## Ashburton - Tinwald Connectivity DBC

**Preliminary Design Stage Road Safety Audit Report**

**Prepared for Ashburton District Council**

REV 0 - JULY 2022

Figure 2-13 – Large Trees in the Existing Median on Chalmers Avenue

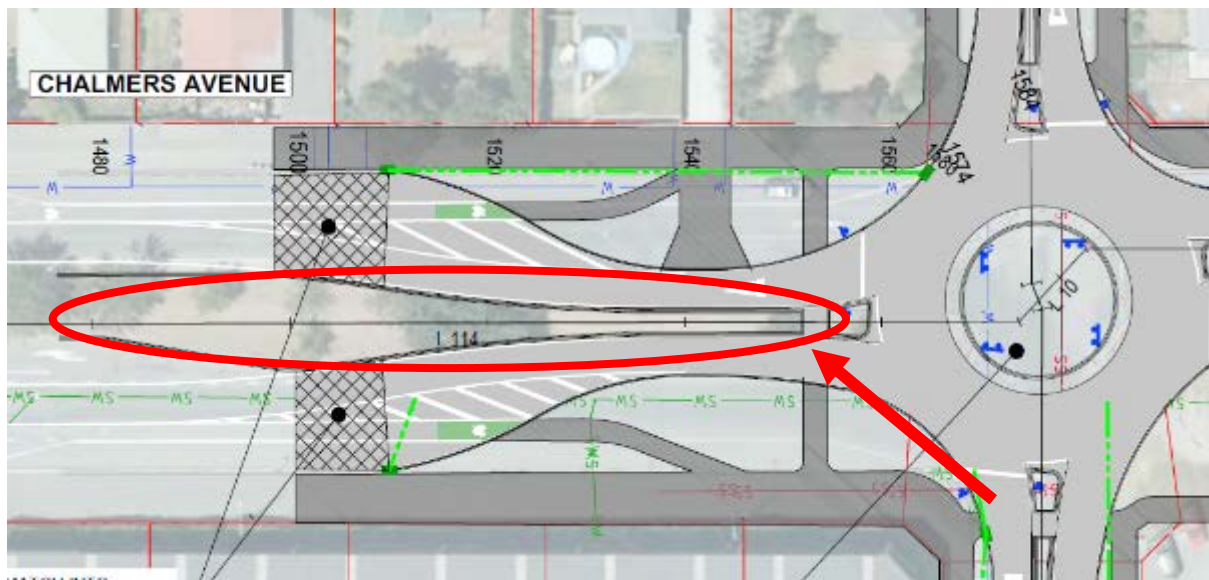
The existing trees located in the median on the northern side of Chalmers Avenue may restrict the visibility for vehicles approaching the roundabout from the north-eastern leg. Although some of the trees will need to be removed to accommodate the proposed roundabout, it is unclear which trees are to be retained or removed.

Adequate visibility is important for all vehicles approaching the intersection and the reduction in visibility reduces the distance and time for a driver to observe and react accordingly, increasing the risk of a conflict.

**Designer Response:** Agree with SAT recommendations

Figure 2-15 – Possible U-Turn Manoeuvres at the Chalmers Avenue/South Street Roundabout

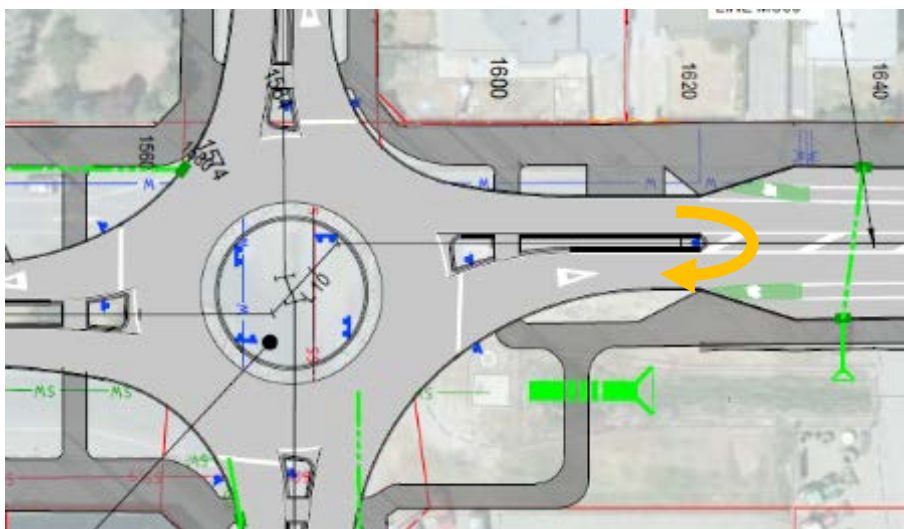
The SAT note that accessways near the proposed roundabout will become left-in left-out (LILO) with the new splitter islands. This is generally not an issue for accessing the site, as vehicles approaching from the opposing side can turn-around at the roundabout. However, drivers wishing to exit and head north will need to turn left and then turn-around. When travelling south, there are no formal facilities to turn around before the next intersection at Carters Terrace, as shown in Figure 2-14. Drivers are unlikely to want to cross the bridge to the south and turn around at the next intersection due to the additional distance they would have to travel, as shown in Figure 2-15. This may encourage unsafe U-turn manoeuvres near the roundabout resulting in conflicts with opposing vehicles or cyclists. A mitigating factor would be the lower turning and approaching speeds near the roundabout.

1. Confirm vehicle tracking at vehicle crossings near the intersections is acceptable
2. Provide a kerbed median, similar to the splitter island at the intersection of Chalmers Avenue and Grahams Road to allow vehicles to turn out of nearby accessways
3. Consider providing a safe turn-around facility between the intersection of Chalmers Avenue and South Street and the new bridge

1. Vehicle tracking to be confirmed at specific accessways during detailed design.
2. Dropped area through island has been added to this splitter island to allow for right turn out movements.
3. Disagree with SAT, providing a specific U-Turn is not seen as being a requirement, once the design has been modified as per response 2 above, to account for the only likely demand for a U-turn. The current carriageway width of 12m (including the cycle lanes) allows for on road U-turn manoeuvres to be completed if required, as would be the case for a vehicle leaving the on street parking and wanting to return in the opposite direction.

**Action Taken:** Vehicle pass through area has been added to the design splitter island on this approach, to be developed during Detailed Design

Figure 2-16 – Transition Between On-Road Cycle Lane and Shared Path Near a Vehicle Crossing

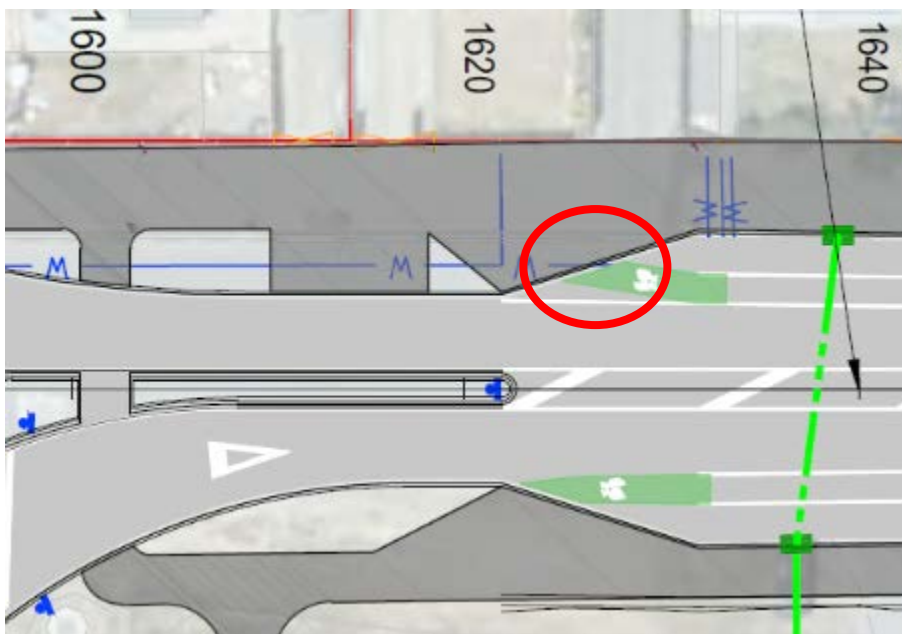
The proposed design includes several transitions between the on-road cycle lanes and the shared path facilities. At CH1620 there is an existing vehicle crossing that intersects the cycle lane transition from shared path to cycle lane south of the proposed roundabout. This may lead to conflicts between cyclists entering the on-road facility and vehicles accessing the property. Although speeds are likely to be low, the conflict with vulnerable road users may result in serious injury.

Furthermore, the type of cutdown used for the cycle ramp transition has a lower profile than that of a vehicle crossing. The SAT note these details may be developed further at the next design stage. However, as no further information has been provided, it is assumed the cyclists and vehicles will share the same cutdown and it should be safe for all users.

1. With multiple accessways in this area conflict points are impossible to avoid, although consideration will be given to these at detailed design stage.
2. Final detail to be developed during the next project phase. Acknowledgment is given to the difference between an accessway cutdown (with short kerb upstand remaining) and pedestrian/cyclist cutdown (flush invert).

**Safety Engineer:** *Agree with the designer response. However, designer could adjust the cycle transition to avoid a driveway that is used by multiple properties.*

Figure 2-17 – Large Hatched Shoulders North of the Proposed Roundabout

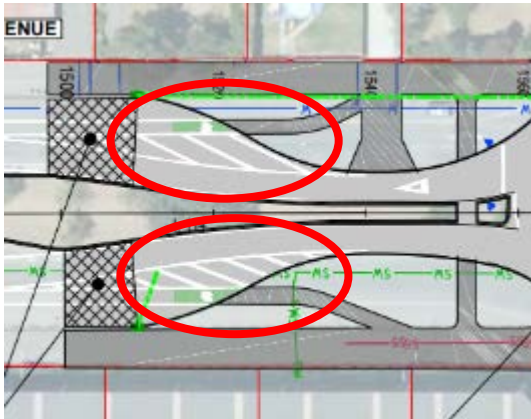
The proposed design includes large, sealed areas with chevron line marking to the north of the roundabout that could be used as on-street parking. Parked vehicles may restrict the visibility between cyclists and through traffic, increasing the likelihood of conflicts between cyclists and turning vehicles. A vehicle may also block the cycle ramp.

**Safety Engineer:** Agree with the designer response. However, delineators could be installed in the chevron line markings to discourage on-street parking in the area.

Figure 2-18 – Stormwater Basins, Ch 3220-3300

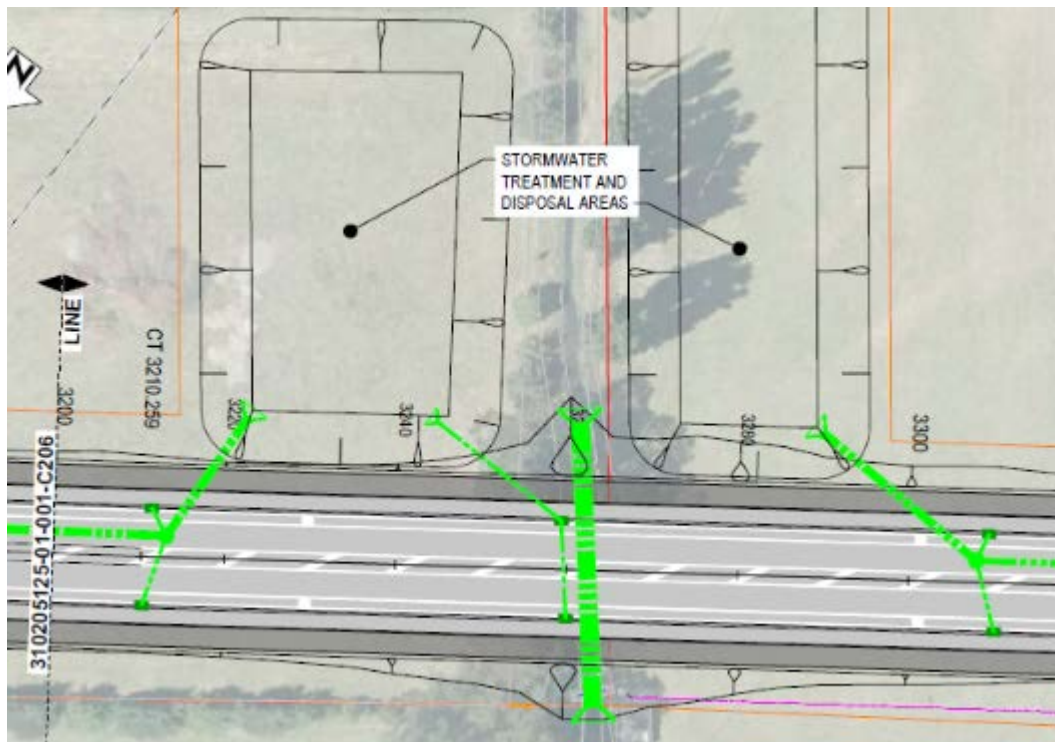
Two stormwater treatment basins are proposed to the south of the new road alignment, through chainage 3220-3300, as shown in Figure 2-18. The SAT have reviewed the cross-sections, which indicate slopes of 1:4, however, it is not clear if this is the verge slope of the road or the stormwater basin. The stormwater basins may also contain standing water which would be a hazard if any vehicle were to run off the road in this location.

Furthermore, although a 1:4 slope is considered traversable for a car, it is not considered recoverable for cars or trucks. It is considered the minimum safety standard. The SAT acknowledge that some constraints along the corridor may limit slopes. However, a 1:4 slope should be the minimum and where possible, a recoverable slope of 1:6 or flatter be provided, to reduce the risk of rollover.

There is also a headwall on both sides of the road at chainage 3260, where the verge slope is steeper in this localised area. Any errant vehicle in this location is likely to roll or strike the headwall, likely to result in a DSI crash.

**Designer Response:** *Partially agree with SAT recommendations*

Figure 2-20 – Proposed Roundabout at Johnstone Street

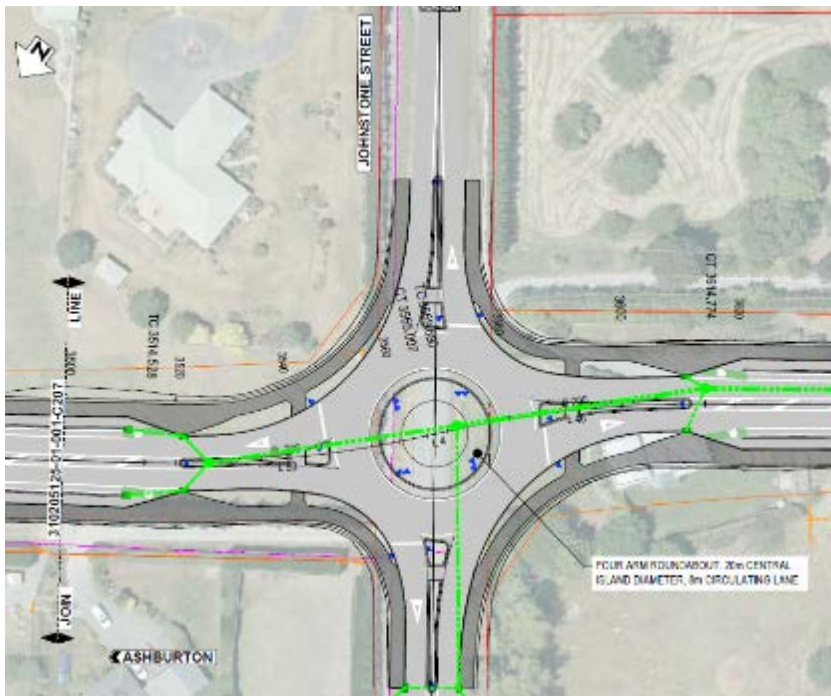
The proposed alignment of the new link road has a slight deviation where it intersects Johnstone Street, as shown in Figure 2-20, which includes the roundabout option. While the proposed roundabout at the Johnstone Street intersection appears to accommodate this offset, if the alternative priority controlled intersection option is adopted, there may be issues with the offset. Although right-angle crossing type crashes can be reduced because of the elimination of the direct crossing manoeuvre, the rural offset intersection is still likely to increase overall intersection crashes when compared to a roundabout, or conventional crossroads.

The SAT acknowledge this may be detailed at the next stage of the design. However, it has been raised to highlight another benefit of installing a roundabout as opposed to a priority controlled intersection.

**Safety Engineer:** *Agree with the designer response. A raised platform could be considered as an alternative option.*

Figure 2-21 – Northbound Vehicle Path at the Proposed Roundabout at Grahams Road

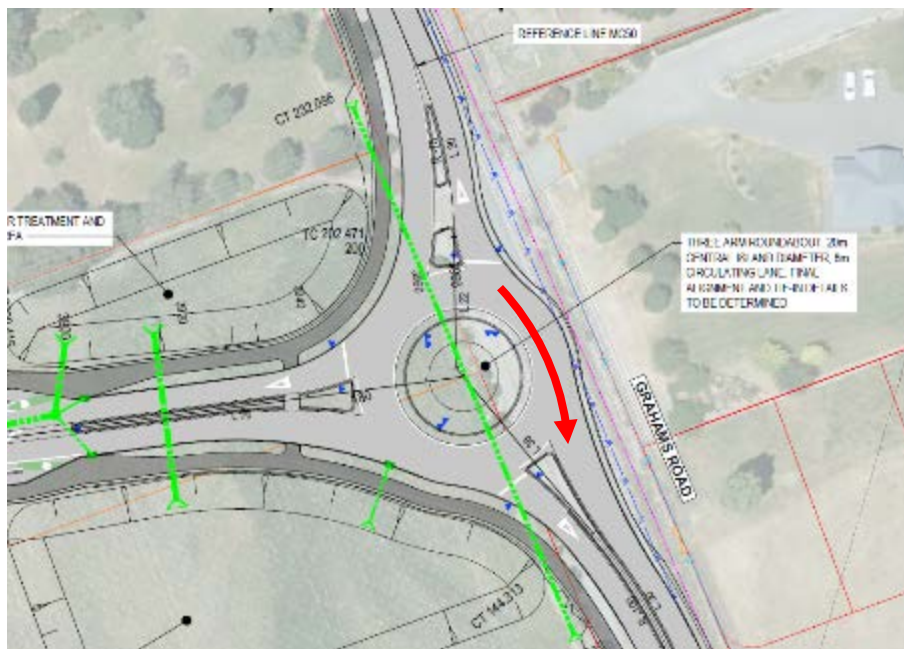
A 3-legged roundabout is proposed at the end of the link road and Grahams Road. The movement from south to north on Grahams Road appears to have minimal deflection which is likely to promote high speed on approach and through the roundabout. Refer to Figure 2-21. This is especially apparent when compared to the north-south movement, which has much higher deflection and subsequently, speeds are likely to be much lower.

It is important to aim to balance the approach legs for roundabouts to avoid speed differential between movements. A southbound vehicle on Grahams Road may approach the roundabout too fast, overshoot the intersection and collide with a vehicle in the circulating lane. It is likely that impact speeds may be in excess of 50 km/h, therefore, above safe system tolerance for intersection crashes.

1. Undertake design modifications to the roundabout to improve deflection for the south-north movement and provide better balance between the 3 legs

**Designer Response:** *Partially agree with SAT recommendations*

Figure 2-22– Left turn movement from Grahams Road

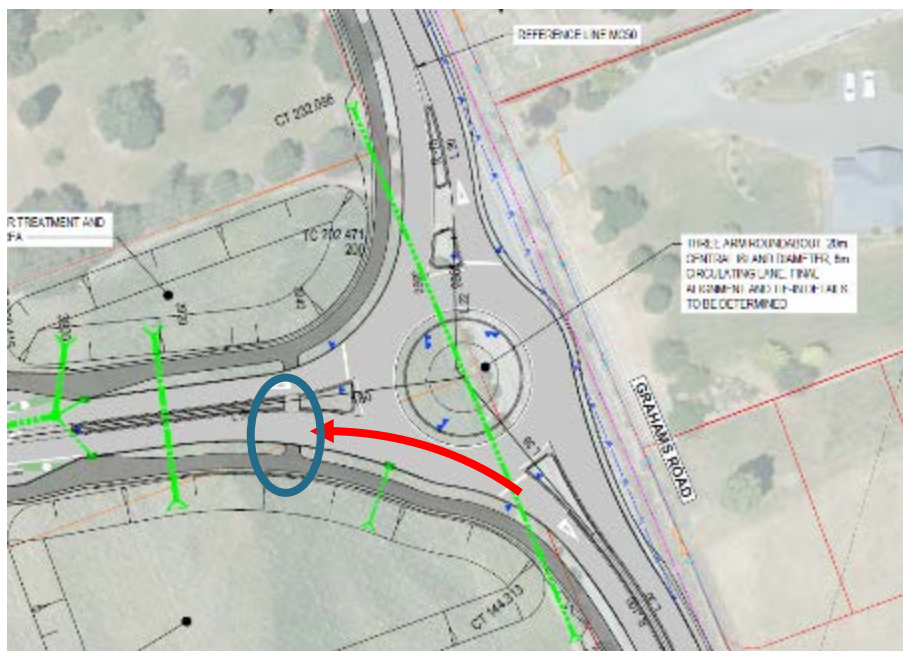
In addition to the high speed movement south-north on Grahams Road, highlighted in 2.8.1 above, there is also a likely high speed left turn movement off Grahams Road. Refer to Figure 2-22. This movement will be largely unimpeded except for give way to any circulating vehicle or right turn from Grahams northbound. The left turn movement is likely to be undertaken at high speed, as sightlines appear good (their view will be largely straight ahead to any circulating vehicle or southbound vehicle on Grahams) and there is relatively little deflection.

The main concern is impact with any pedestrians or cyclists using the crossing point on the new link road. Path users will be vulnerable as they will have little time to react to high speed left turn movements. Any crash will vulnerable road users in this location is likely to result in a DSI as the impact speed would far exceed the safe system survivable speed (<30 km/h impact speed).

1. As per response to item 2.8.1 above, design to be refined during the next design phase. But is currently a compromise due to property restrictions.
2. A raised platform to be considered during the Detailed Design phase

**Figure 2-23 – Gap in Splitter Island at the Grahams Road Roundabout**

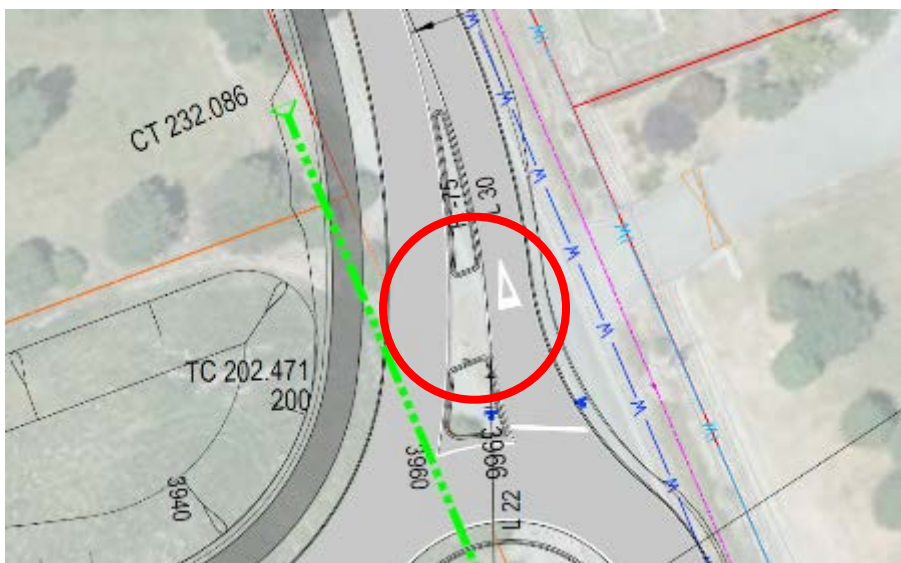
The proposed design shows a gap in the splitter island on the southern leg of the roundabout near the property access on the western side of Grahams Road (shown in Figure 2-23). It is assumed this is to allow vehicles to turn right in-and-out of the property. However, the gap does not appear to be large enough for vehicles to safely perform the manoeuvre. This may result in blockage at the exit of the roundabout, resulting in nose-to-tail crashes. Road users will be confused by the turning movements so close to the roundabout (particularly right turn in) and the turning vehicle indicators may also confuse drivers, leading to crashes.

The SAT acknowledge this may be detailed further in the next design stages. However, as no vehicle tracking has been provided for this access, it is unclear what vehicles it has been designed for and if they will be able to manoeuvre through the gap.

**Designer Response:** Partially agree with SAT recommendations

**Figure 2-25 – Access to New Subdivision**

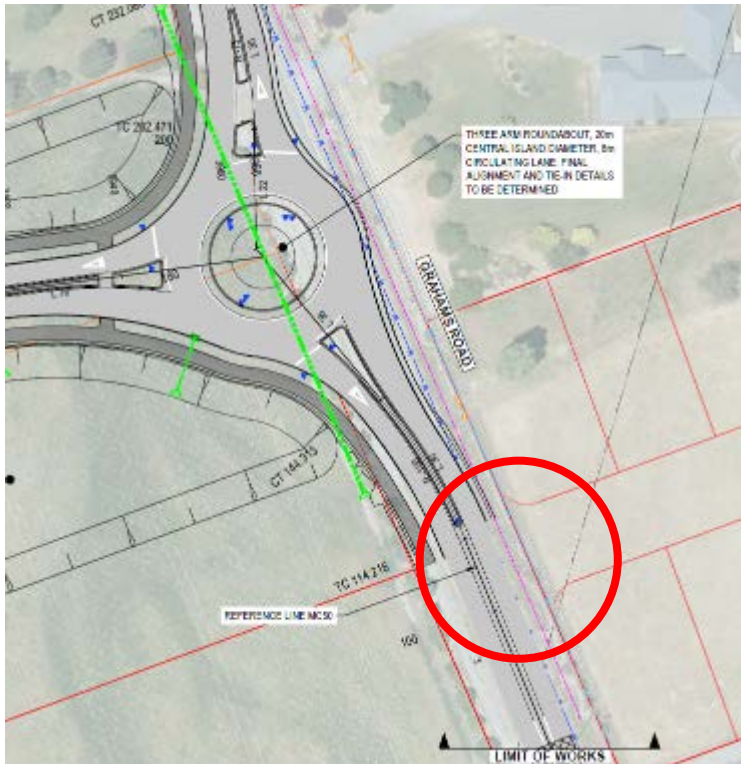
An adjacent new subdivision is currently under construction immediately south of the proposed roundabout, with access off Grahams Road, as show in Figure 2-24 and 2-25. The SAT raise the following comments:

- The subdivision is likely to generate high levels of traffic, with turning movements at an access close to the roundabout
- It would be desirable to have the subdivision access off a fourth leg of the roundabout, if possible
- The subdivision will also generate additional pedestrian and cycle movements. This will lead to increased demand for a shared path along the west side of Grahams Road

1. Investigate whether the roundabout can be re-designed to access the subdivision off a fourth leg
2. If the access has to remain, undertake additional widening and provide a right turn bay into the subdivision
3. Consider future shared path design along the west side of Grahams Road

**Client Decision:** Agree with the designer response. Not sure there will be high levels of traffic from the subdivision which has access from both Grahams Rd and Grove St at the other end of the subdivision.

Figure 2-24 - Proposed Stormwater Basin at the Grahams Road Roundabout

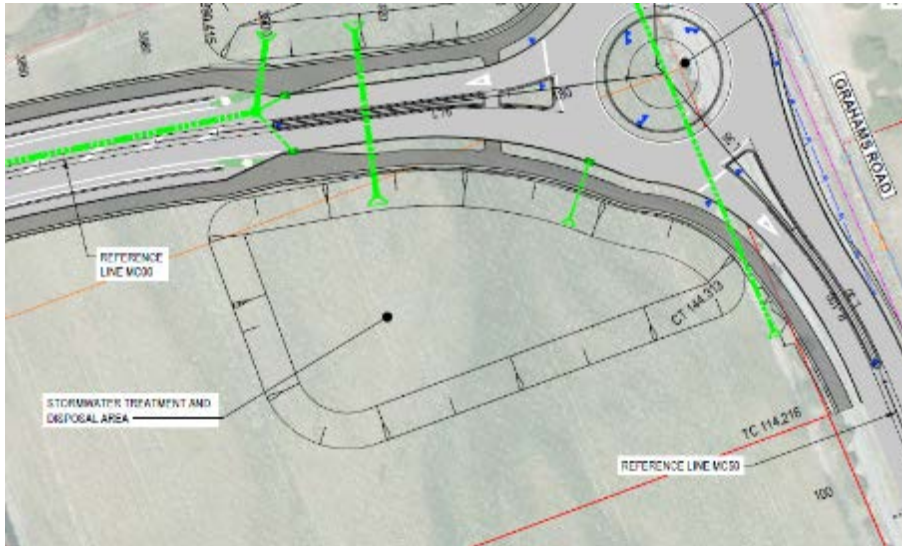
The proposed design includes a large stormwater basin on the northern side of the Grahams Road roundabout. No further details have been provided and it is unclear what the gradient of the side slopes are or how deep the basin will be. As the basin is located near the roundabout (on outside of curve), there is an increased likelihood of an errant vehicle reaching it. If the side slopes are not traversable, an errant vehicle may overturn, resulting in injury to the occupants of the vehicle.

1. Provide further details of the stormwater basin, including typical cross-sections, side slopes and depth

**Designer Response:** Partially agree with SAT recommendations
